Addendum #3

Project: 2024 – Fishers Elementary School Addition & Renovations

PROJECT NO: 2021119 DATE: 02/09/2024 BY: Josh Cannaday

DRAWING NUMBER
A201A

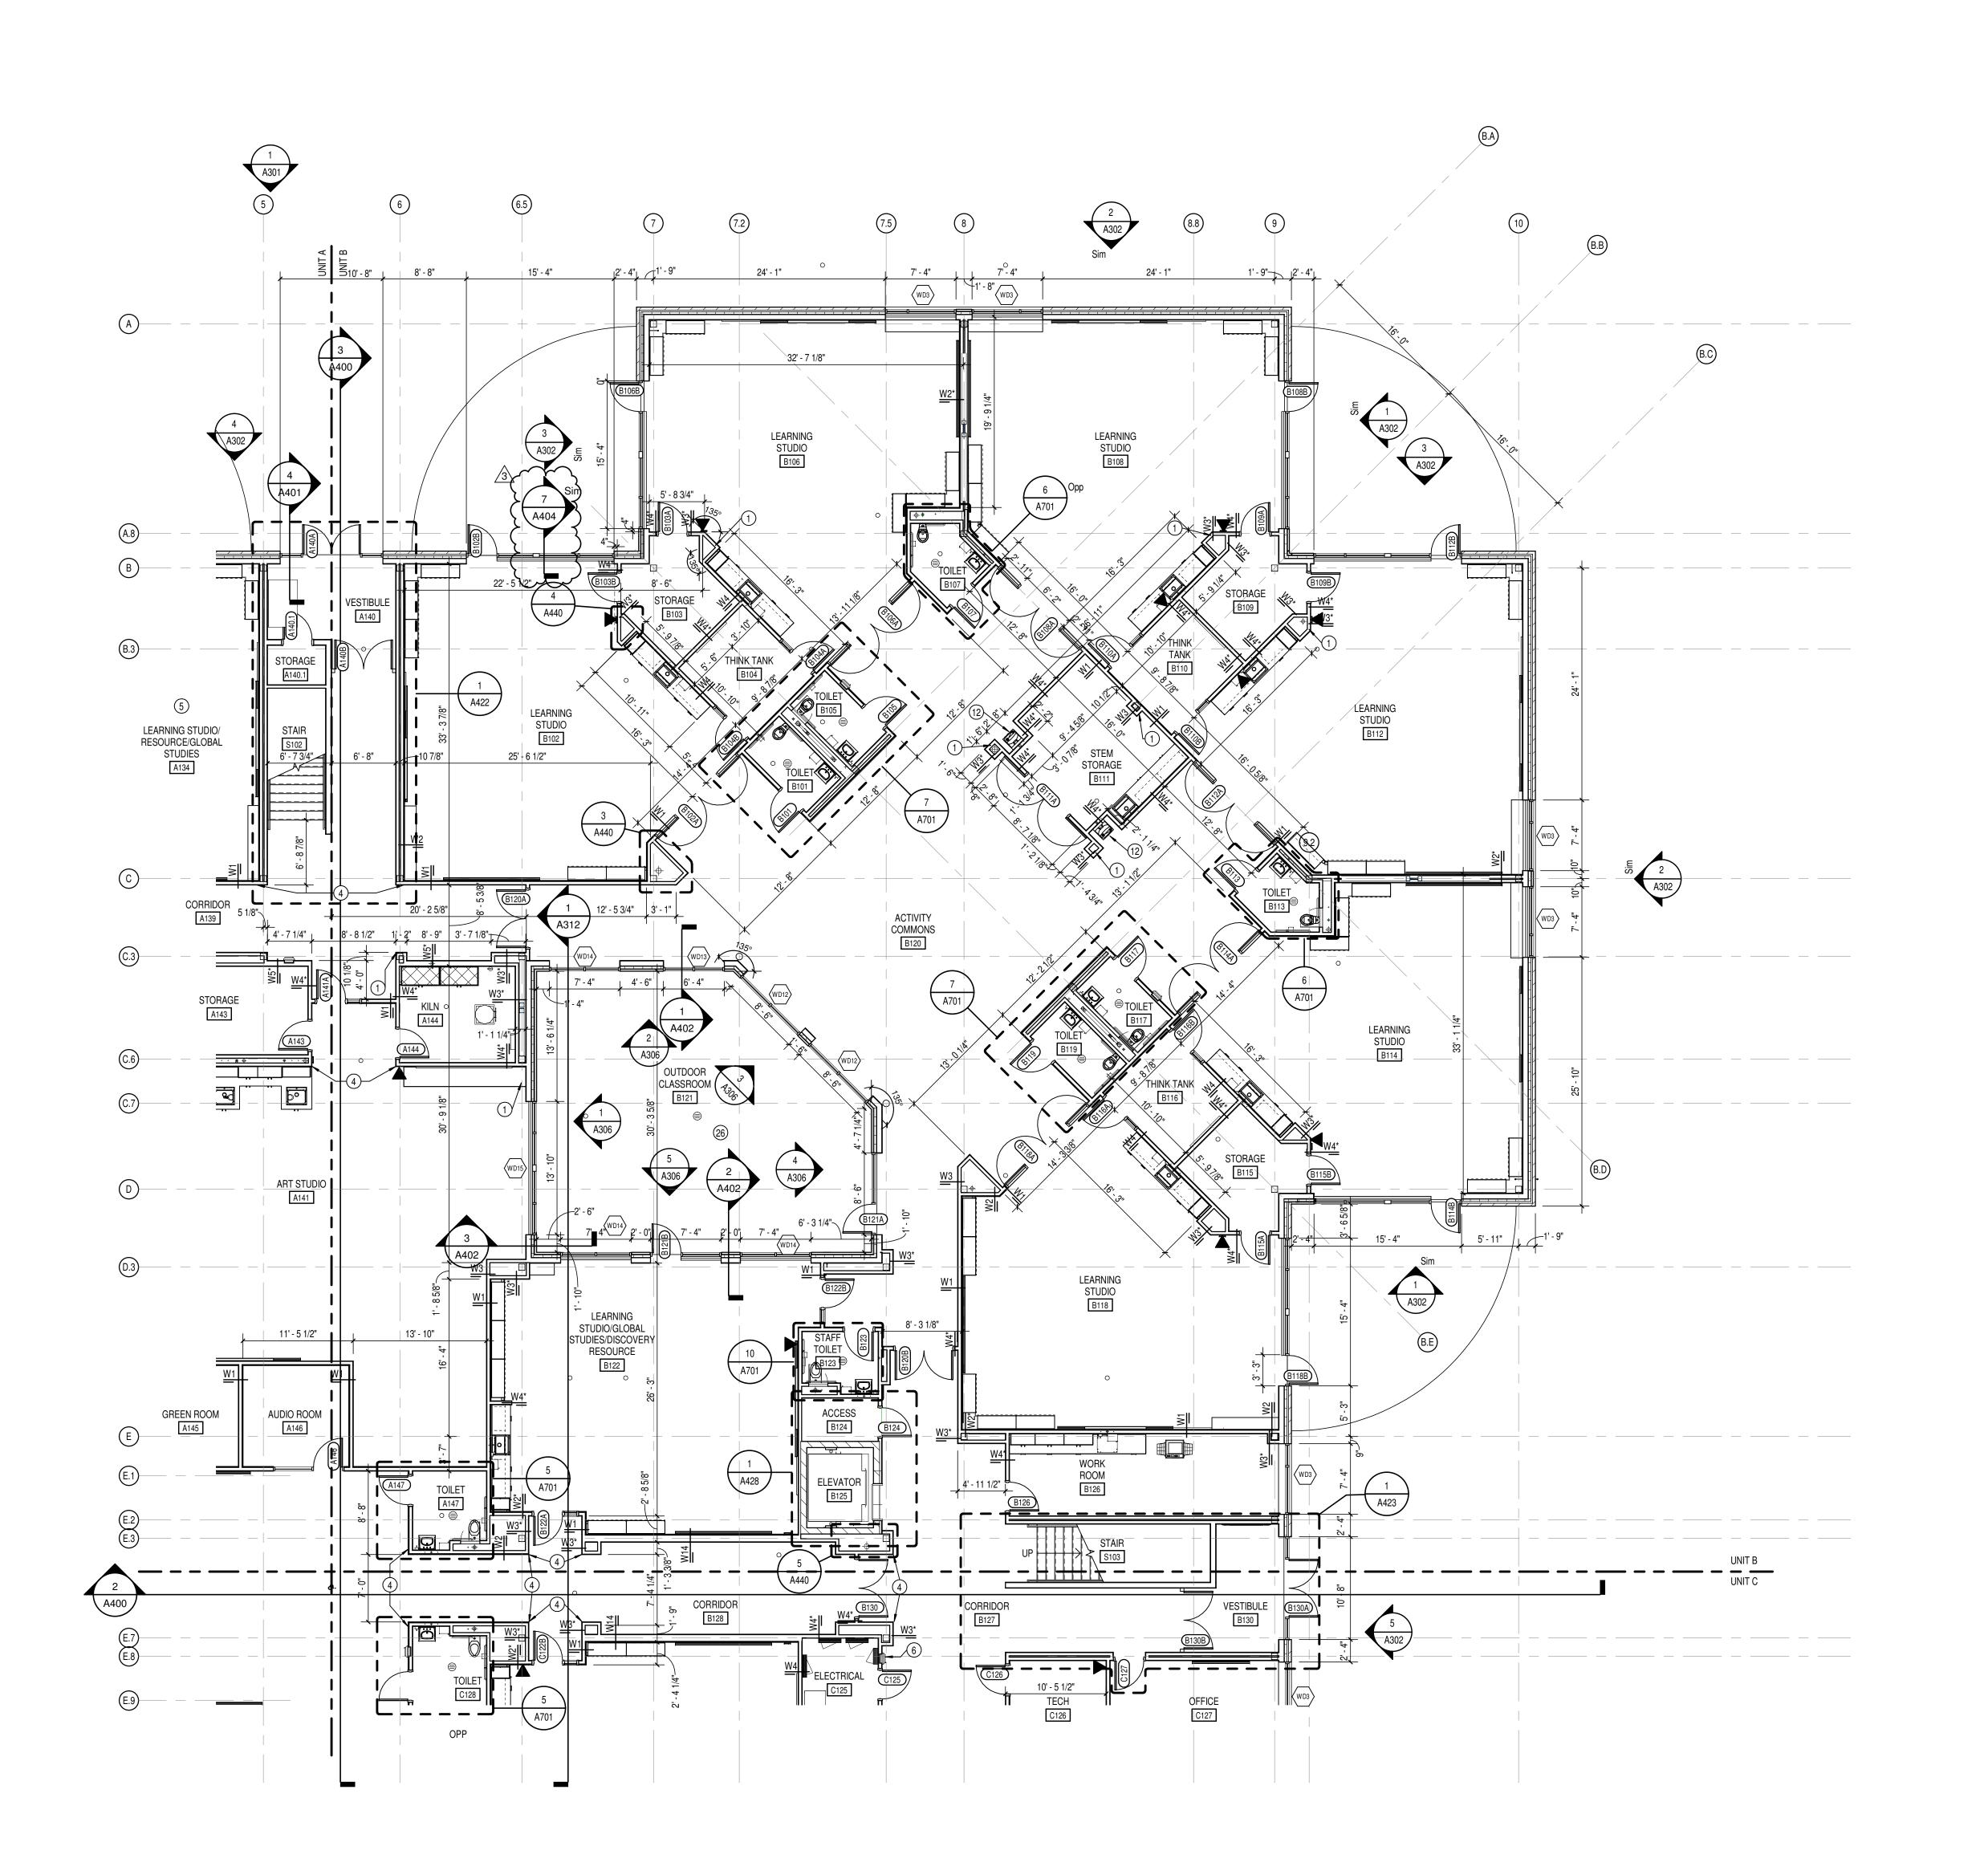
- A. Add section cut 7/A404 at room A134
- B. Tag BL1 outside of Waiting A101
- C. Add chase wall in Storage A143 and A155

DRAWING NUMBER A201B PROJECT NUMBER 2021119

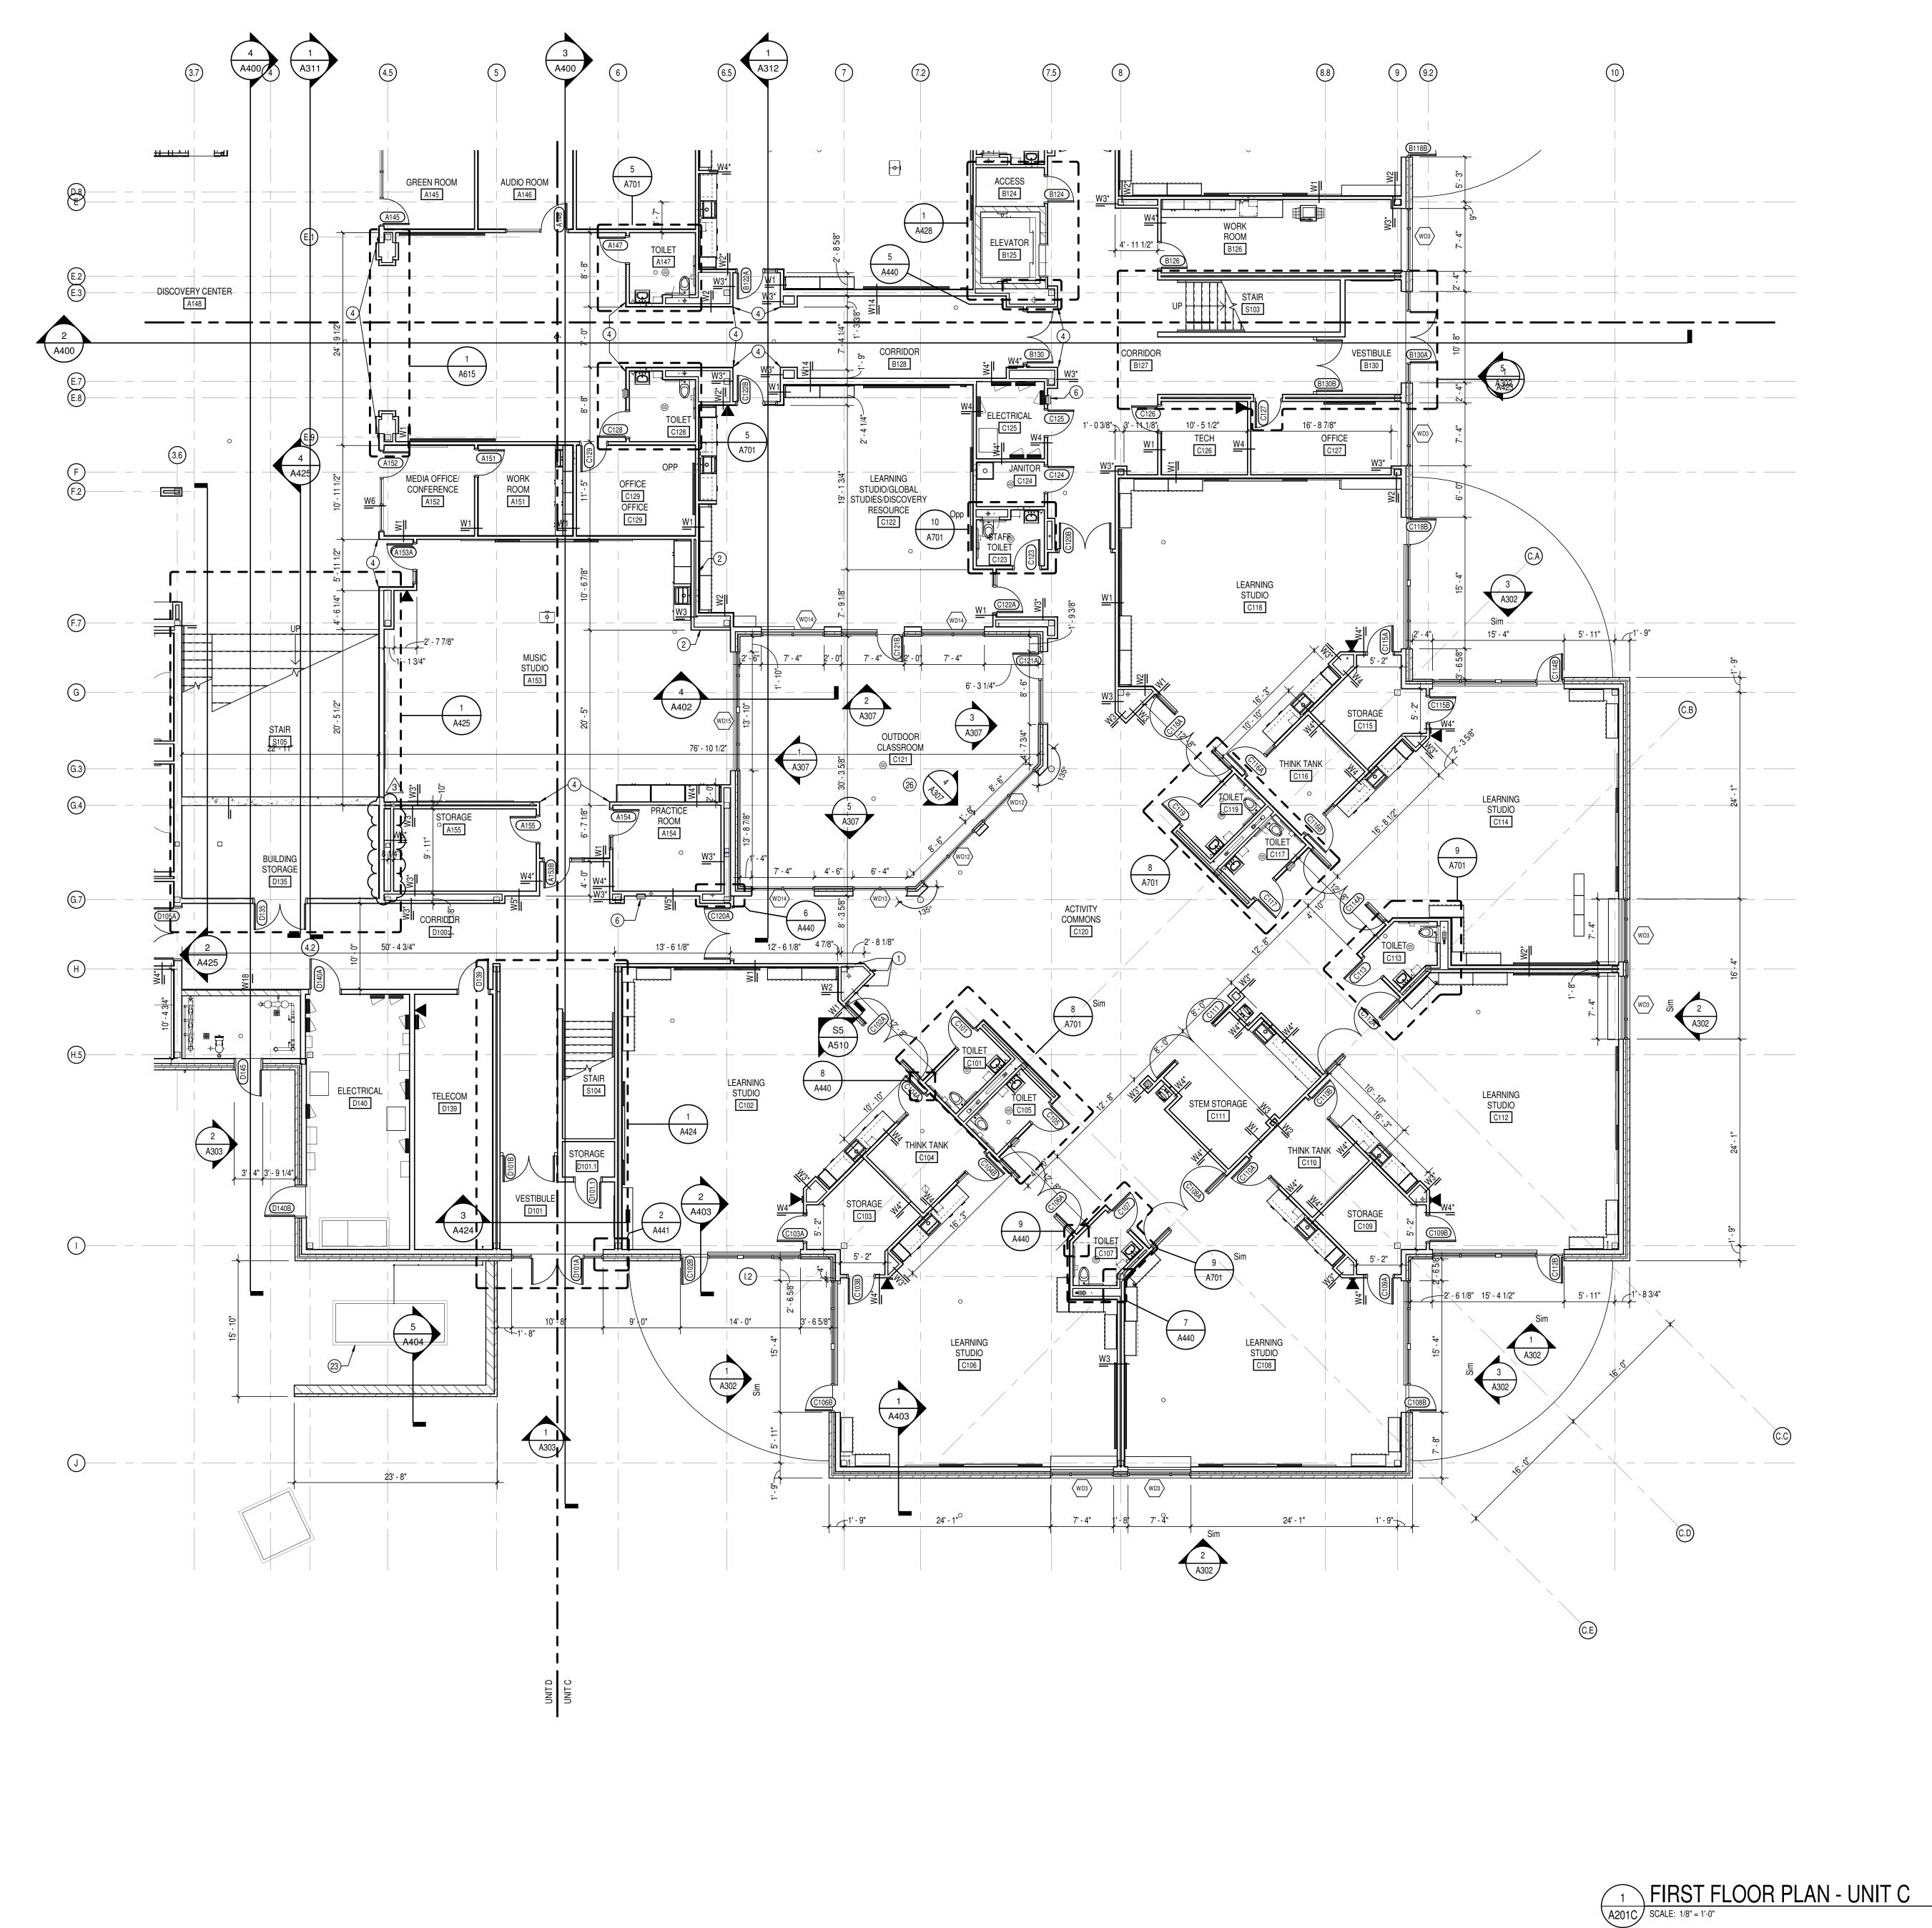
A. Add section cut 7/A404 to room B102

SECOND FLOOR PLAN - UNIT A

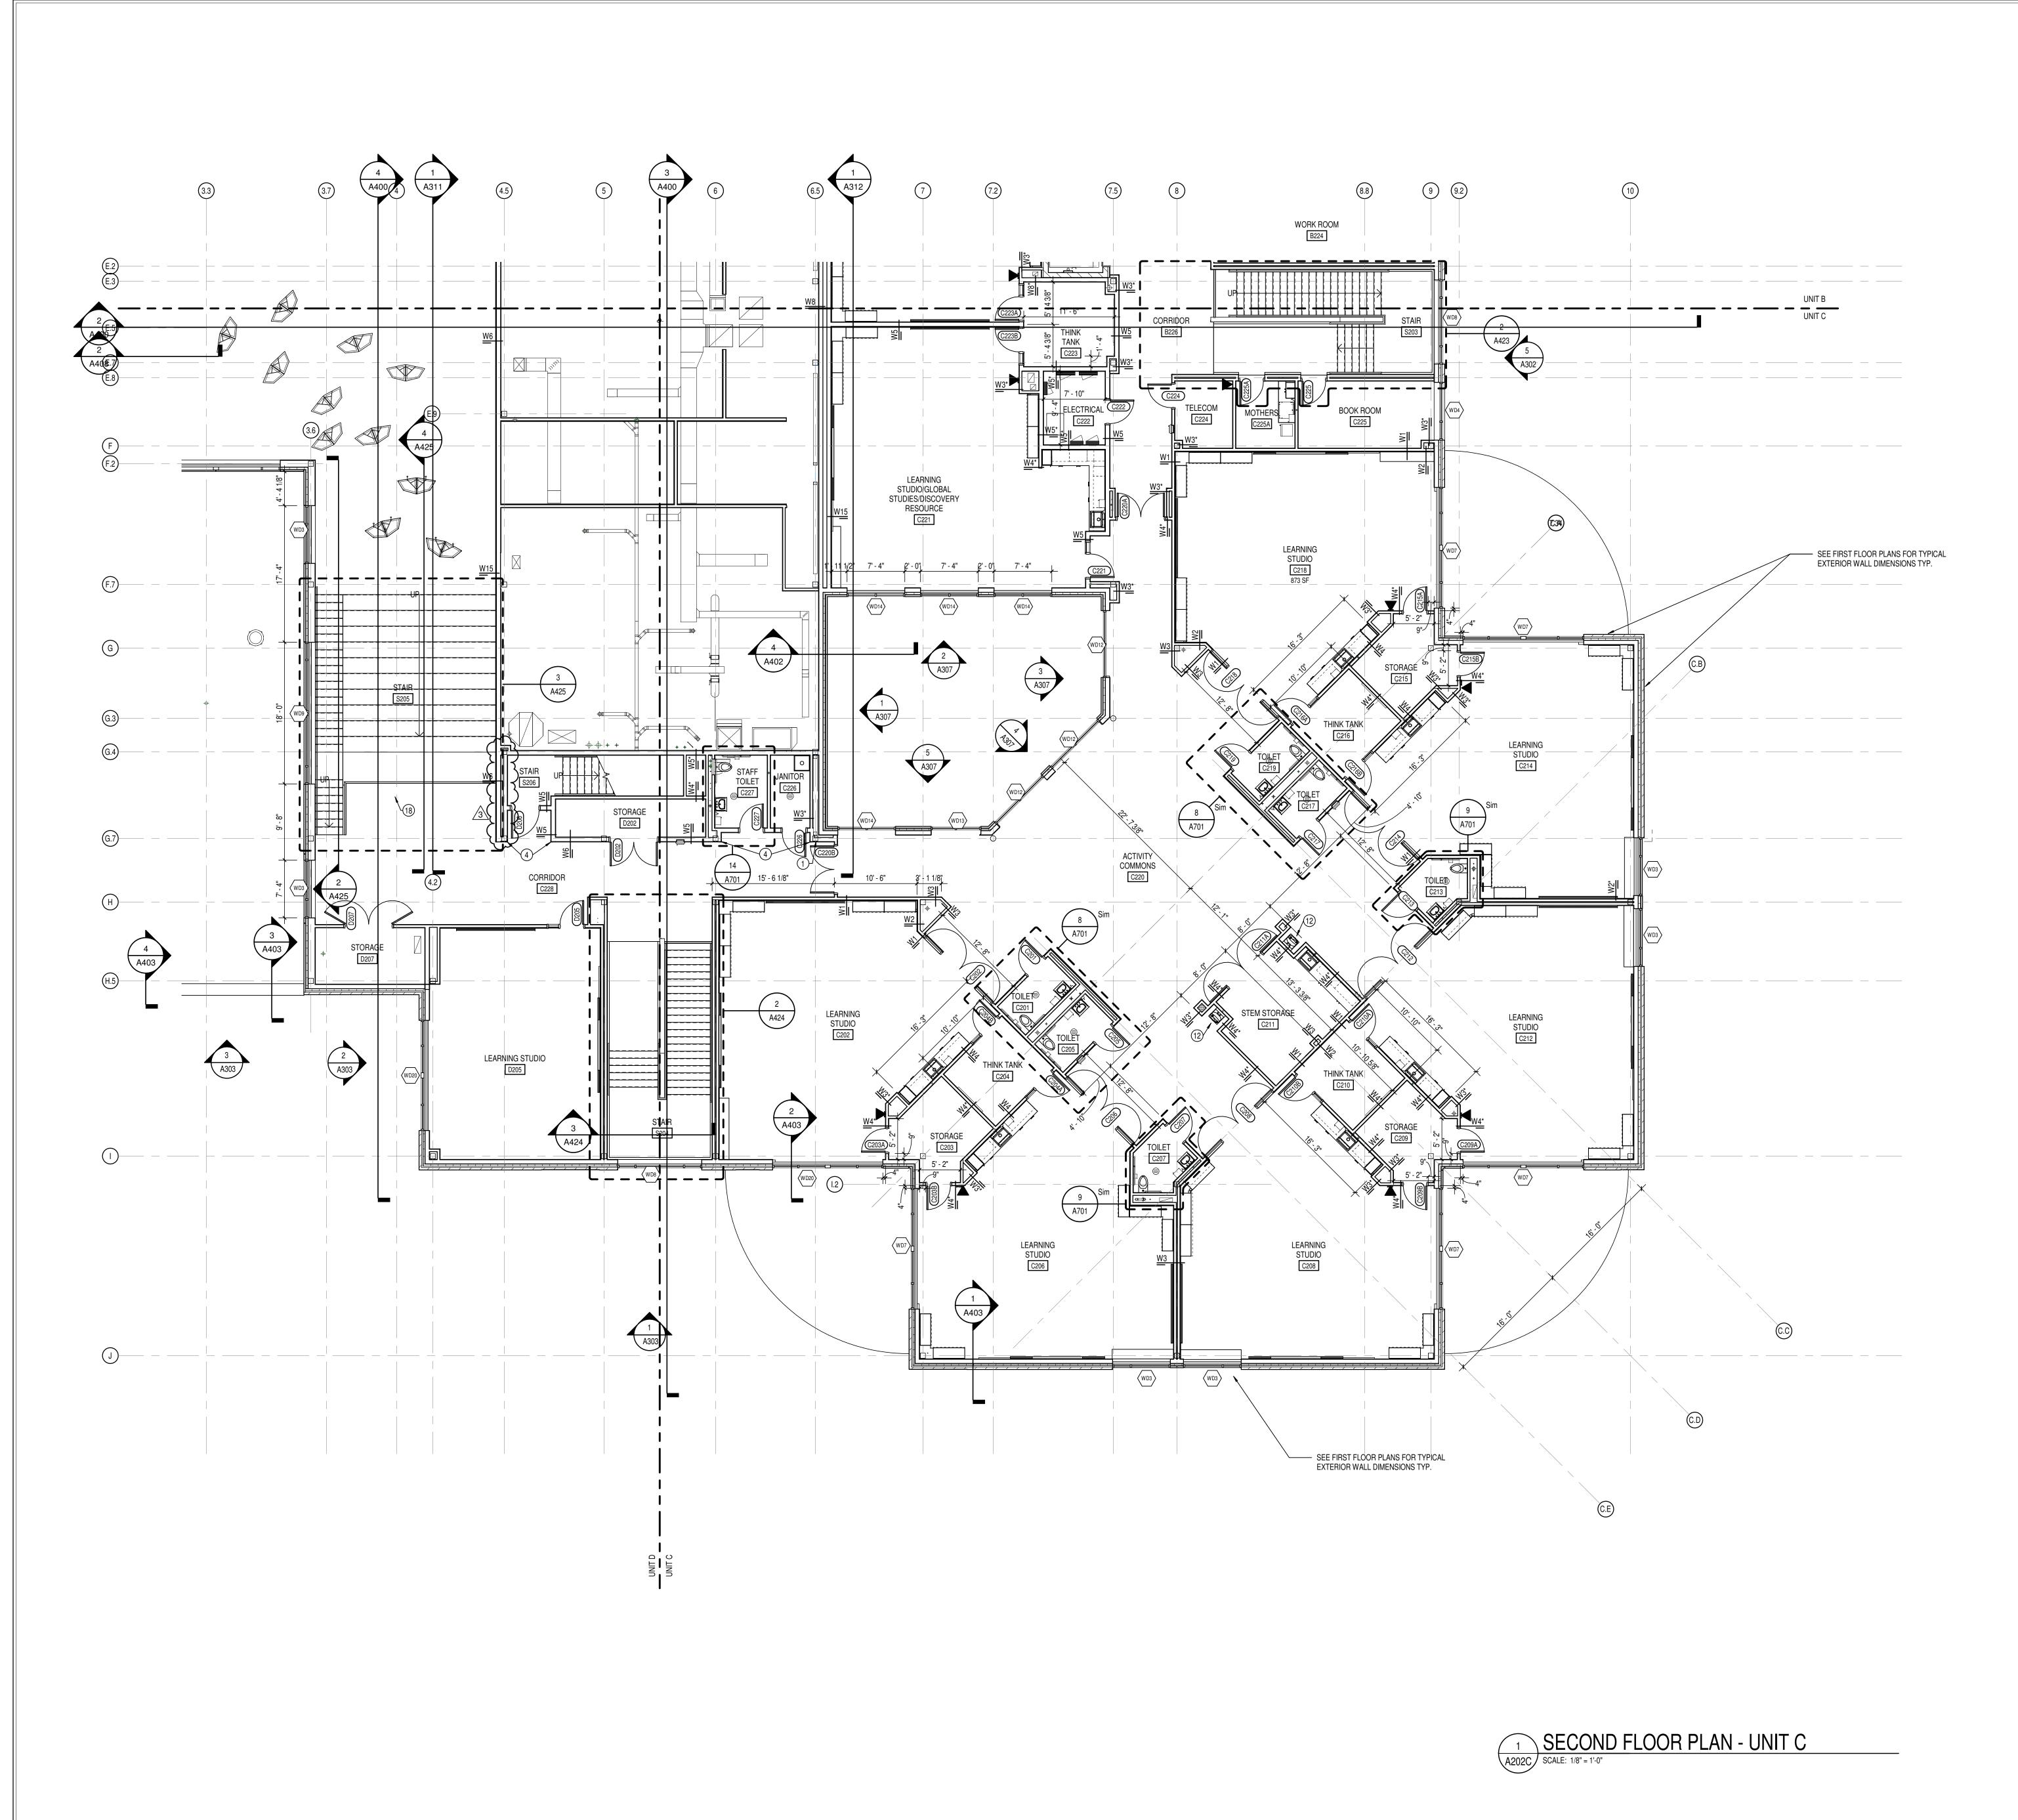
A. Add wall chase in Telecom A224
